Subject: Responses to Cygna Design Control, Pipe Support, and Pipe Stress  
Questions  
Comanche Peak Steam Electric Station  
Independent Assessment Program - Phase 3  
Texas Utilities Generating Company  
Job No. 84042

Subject ATTACHMENT C TO JUNE 8TH LETTER TO N. WILLIAMS (CYGNA)  
FROM L. POPPLEWELL (TUGCO)

TEXAS UTILITIES GENERATING COMPANY  
COMANCHE PEAK STEAM ELECTRIC STATION  
G&H PROJECT NO. 2323  
PHASE 3 CYGNA PIPE SUPPORT QUESTIONS  
WOS-046/DOW-3464

Date 6-19-84Calc By GMCChk'd/Approved By THB 6-21-84Subject CC-1-028-007-533R

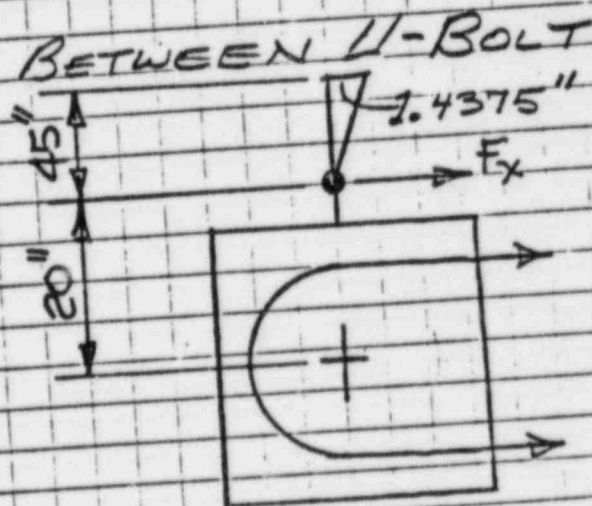
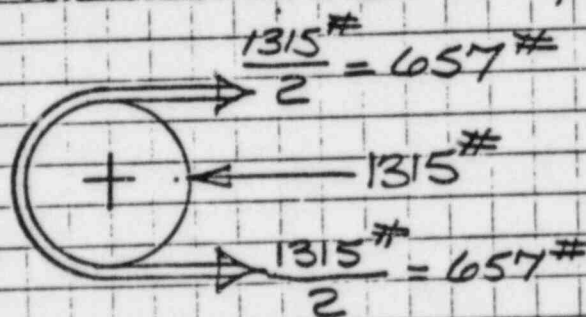
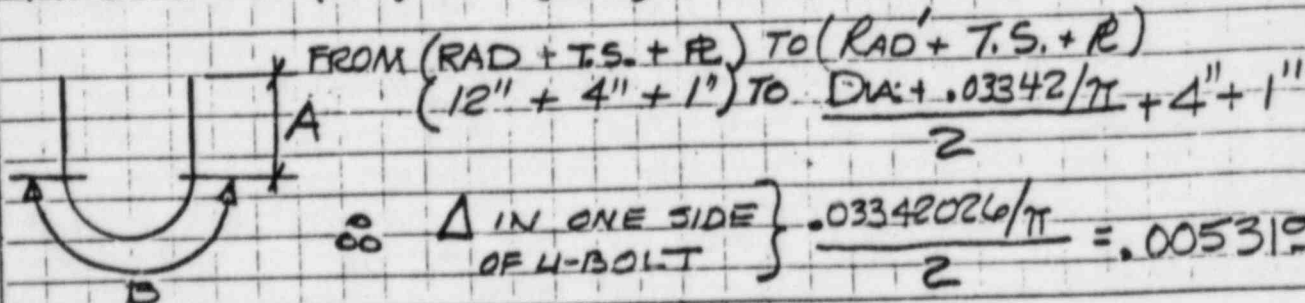
The calculation for hanger CC-1-028-007-S33R was revised to properly account for the elongation of the U-bolt due to thermal expansion. Attached is the revised calculation.

**OBJECTIVE:** THE CALCULATIONS DATED 3/23/84, BY "A.T.", TO DESIGN U-BOLTS ADDED TO ENHANCE LATERAL STABILITY, HAD AN ERROR IN THE CALCULATIONS. ON PAGE 40 OF 60 OF THE REE'D CALCULATIONS, THE ASSUMED LENGTH OF THE U-BOLT IS NOT CORRECT. THE ERROR IS UNCONSERVATIVE, BUT BECAUSE OF OTHER CONSERVATIVE ASSUMPTIONS MADE ELSEWHERE IN THE CALC'S THE DESIGN IS STILL MORE THAN SUFFICIENT. THE FOLLOWING CALCULATIONS WILL DEMONSTRATE THAT.

- TEMPERATURE
- RADIAL EXPANSION OF PIPE DUE TO PRESSURE
- TORQUE ON U-BOLT.

NOTE THAT MSS SP-58, 4.5 STATES THAT PORTIONS OF SUPPORTS IN CONTACT WITH PIPE WILL EXPERIENCE SAME TEMP. AS PIPE.  $\phi$ , SINCE BOTH ARE CARBON STEEL, NO ADD'L PRETENSIONING WILL RESULT IN PORTION B.

Gibbs & Hill, Inc. Job No. 2323 Client TUGCO  
 Subject CONC. PULLOUT CAPACITY OF A.B.s IN GROUPS  
 Calculation Number SRB-123C SET 5 Sheet No. 2

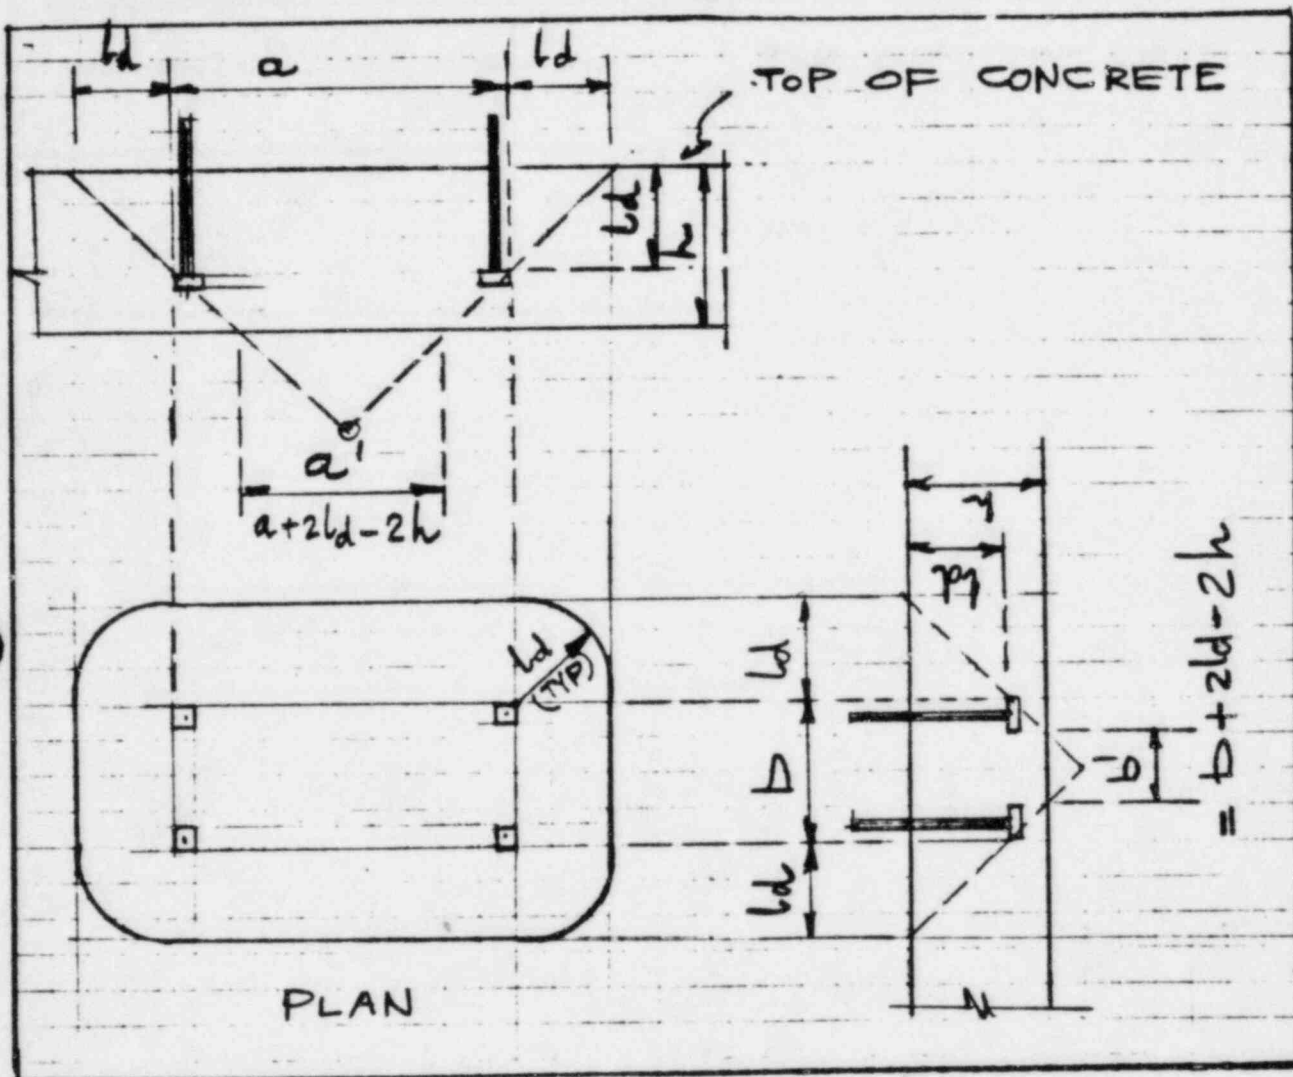
- Question 1: Is there a calculation developing the allowable ultimate pullout load/bolt for 9 or 12 bolt groups with 20 inch spacing? If so, please provide it to justify the 50% reduction noted in GTN-41315.
- 2: Is there a calculation for the same group based on 10 inch spacing? Please provide.

Name	Comments	Req'd Action By
	<p>In reviewing the TUGCO response to item 23 (5/24/84 Telecom), Cyqua needed to verify how the allowable loads <del>are</del> <sup>were</sup> developed.</p> <p>Cyqua, therefore, asked Gibbs and Hill the following:</p> <p>1) Is there a calculation developing the allowable ultimate pullout load/bolt for 9 or 12 bolt groups with 20 inch spacing. If so, please provide it <del>in</del> <sup>to</sup> that justify the 50% reduction noted in GTN 41315</p>

No.	Comments	Req'd Action By
	<p>2) Is there a calculation for the same group based on a 10' spacing. Please provide.</p> <p>3) What thickness wall is needed in these calculations to develop the calculated load in the concrete.</p> <p>4) What justification or calculation does Gibbs and Hill have for the Richmond Inset Load loads presented in GTN 6/6/77.</p> <p>Cygnus requested response no later than 6/18 to meet the phase 3 schedule.</p>

G&H Calculation Book SRB-123C, Set 1 provides the general guidelines as well as some specific sample examples for the evaluation of the embedment capacity of anchor bolts and Richmond inserts. The specific cases referenced in Question 1 and 2 are not included in the sample examples.

However, reference is made to GTT-10394 where the subject cases in Item 5 of GTN-41315 are modified. The modified note limits the number of bolts in a group within which the 50% of the maximum ultimate tensile capacity may be used. Pertinent calculations are in G&H Book No. SRB-123C, Set. 5, Rev. 0.
